#### **F.4     1250 Dallas Road: Development Variance Permit Application No. 00254**

**To:** Committee of the Whole **Date:** April 1, 2021  
**From:** Karen Hoese, Director, Sustainable Planning and Community Development  
**Subject:** Development Variance Permit No. 00254 for 1250 Dallas Road

1250 Dallas Road  
Development Variance Permit No.00254

project name:  
**Variance Application**  
1250 Dallas Road, Victoria, B.C.

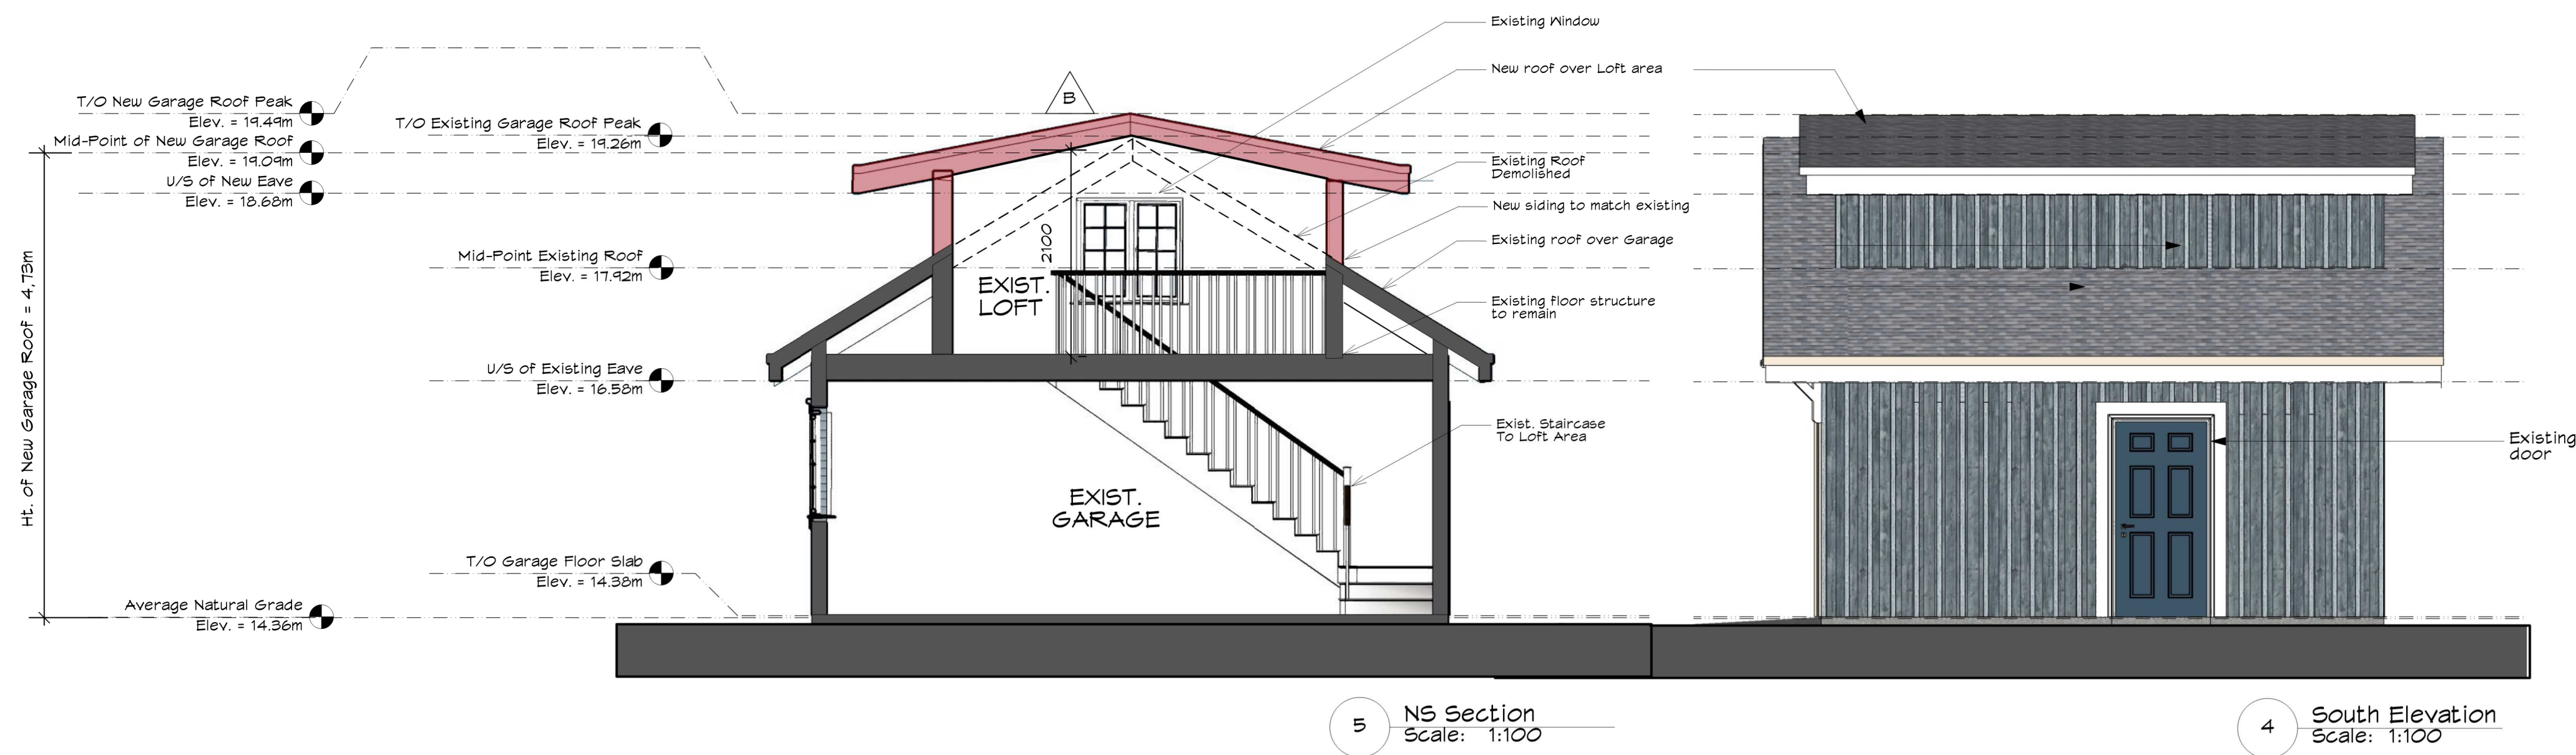
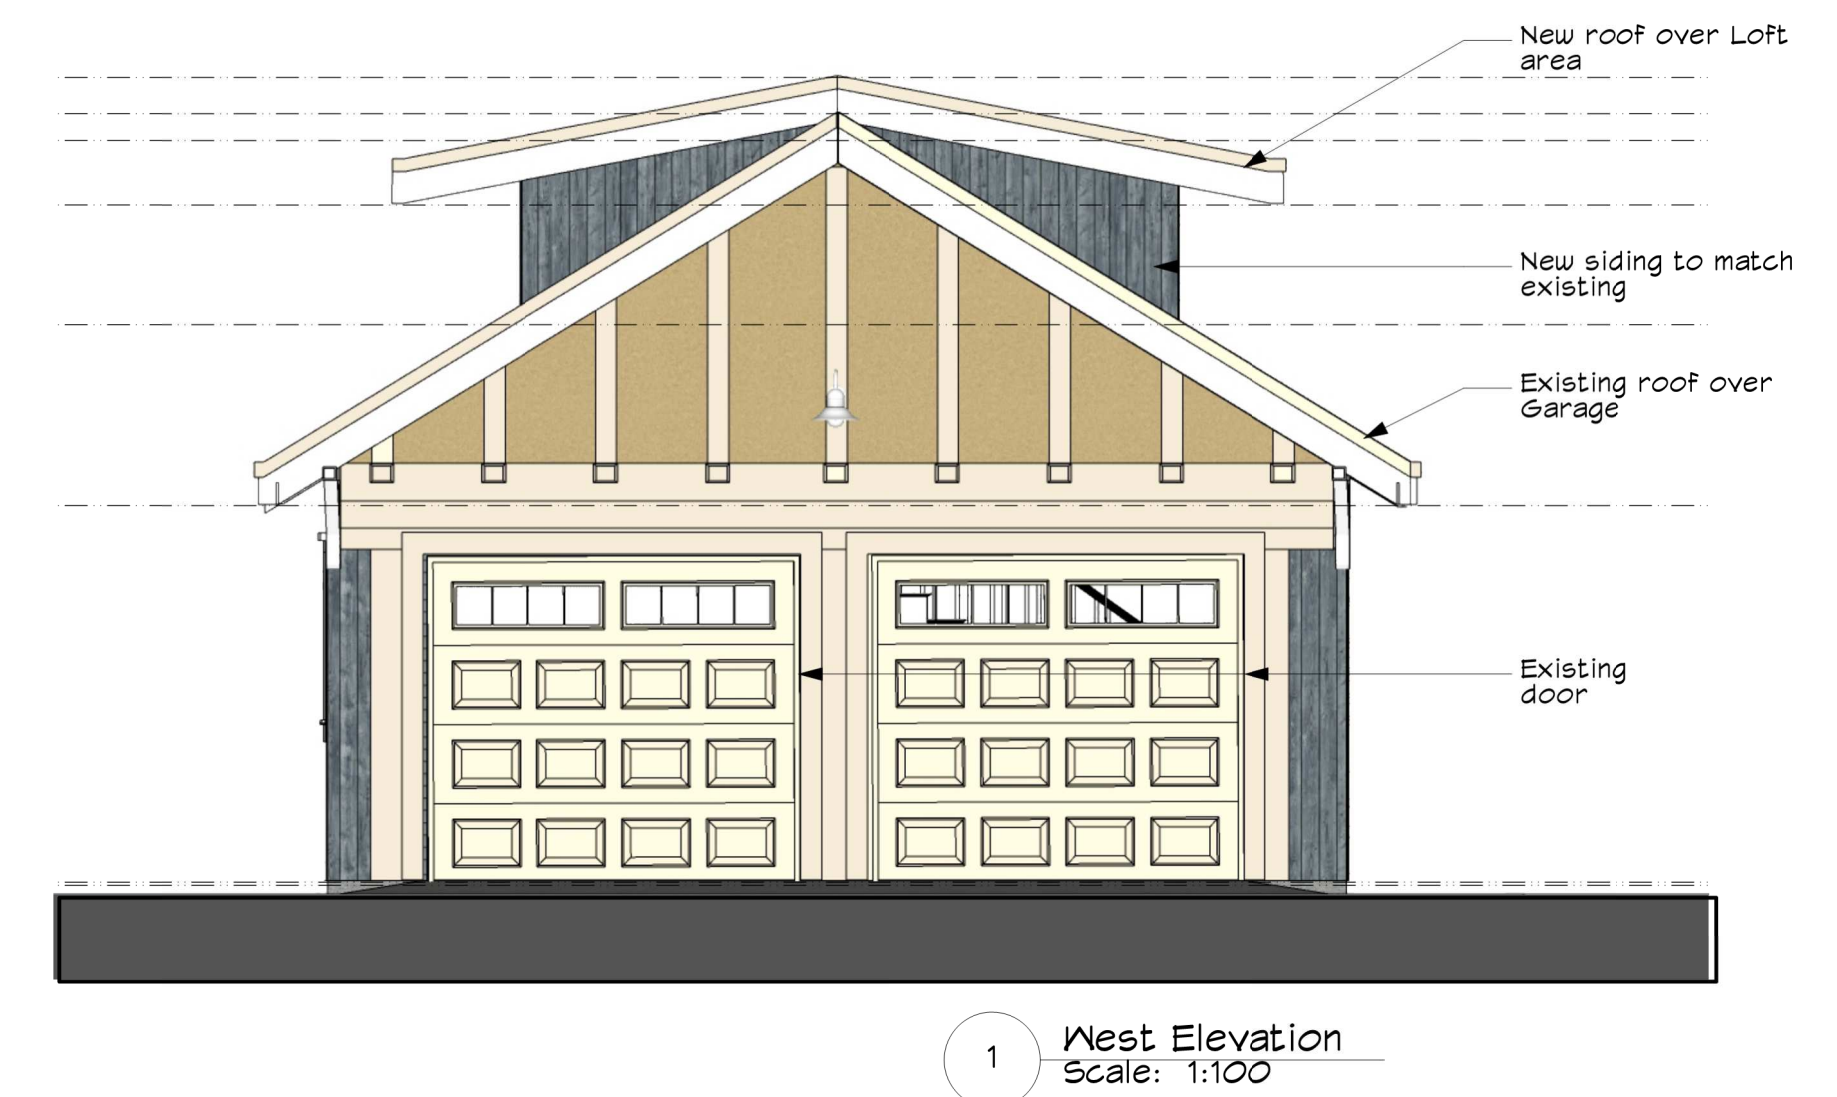
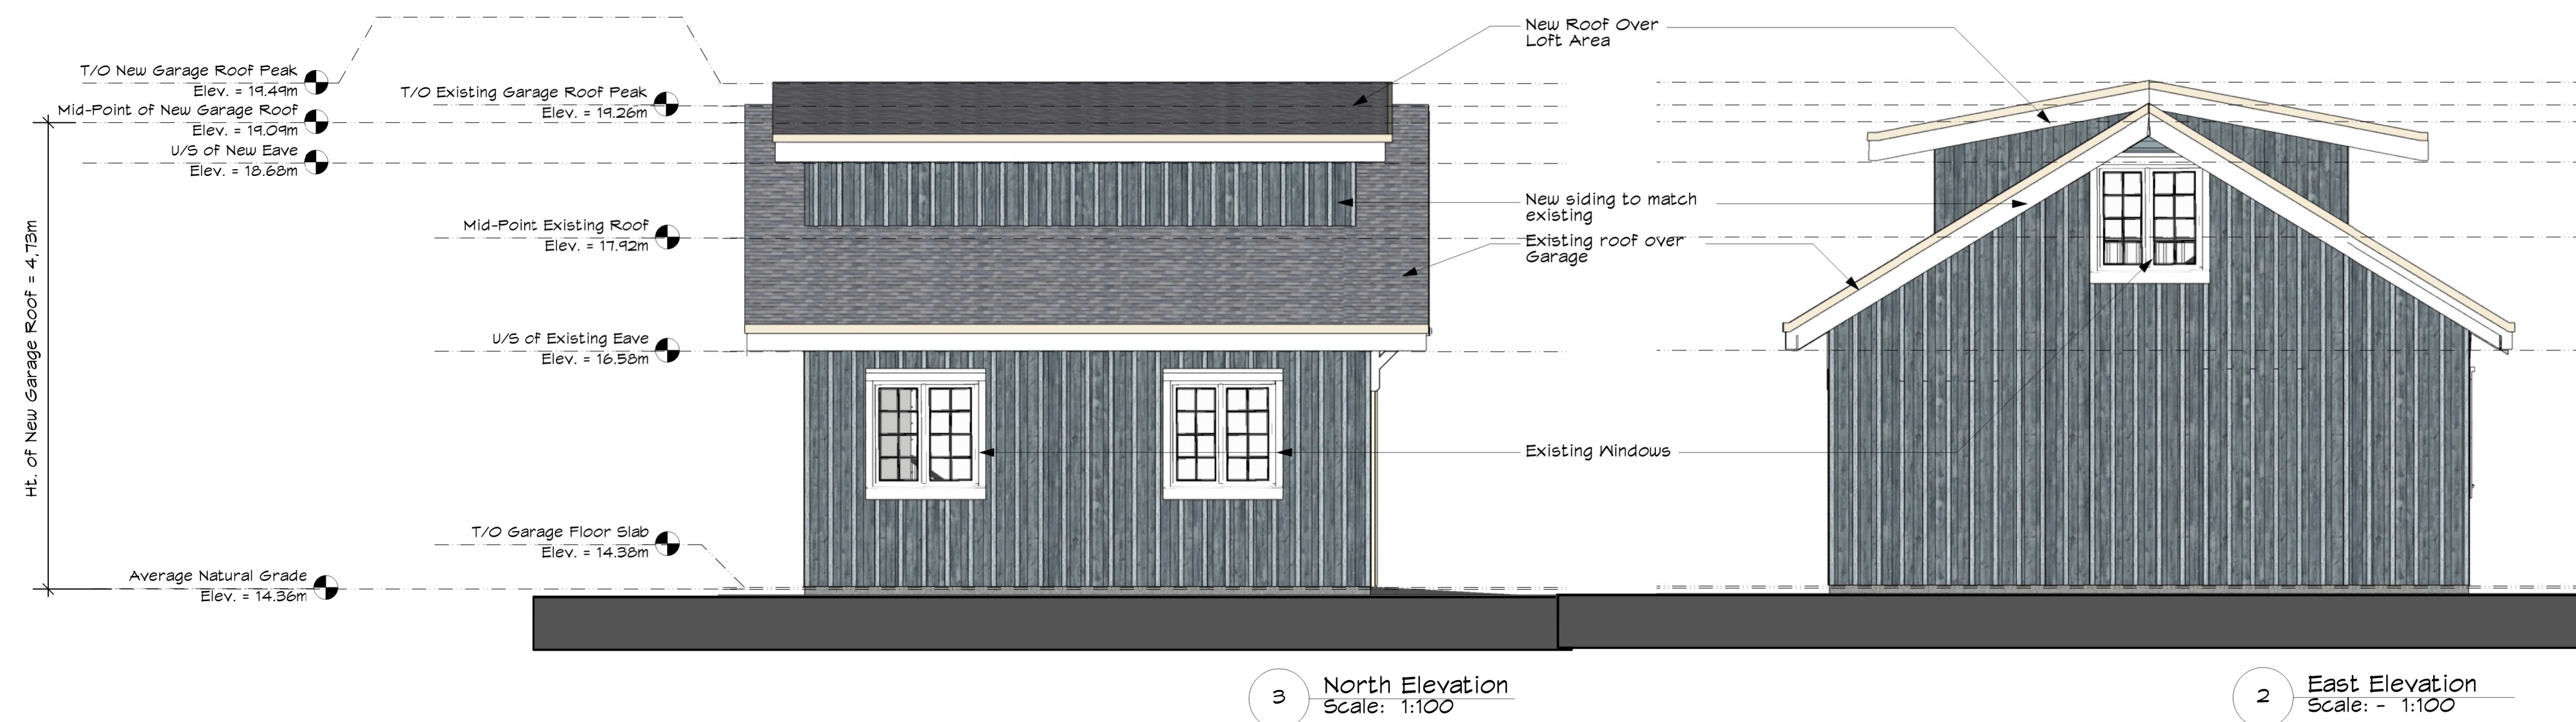
- The accessory building is existing and the main change to the exterior of the building is the addition of shed dormers to provide adequate ceiling height for the loft area. The dormers do not have any windows, and, as such, do not create any privacy impacts.

The design of the dormers is complementary to the residence, which also has shed dormers. The dormers on the accessory building do not have windows and, as such, present no privacy issues.
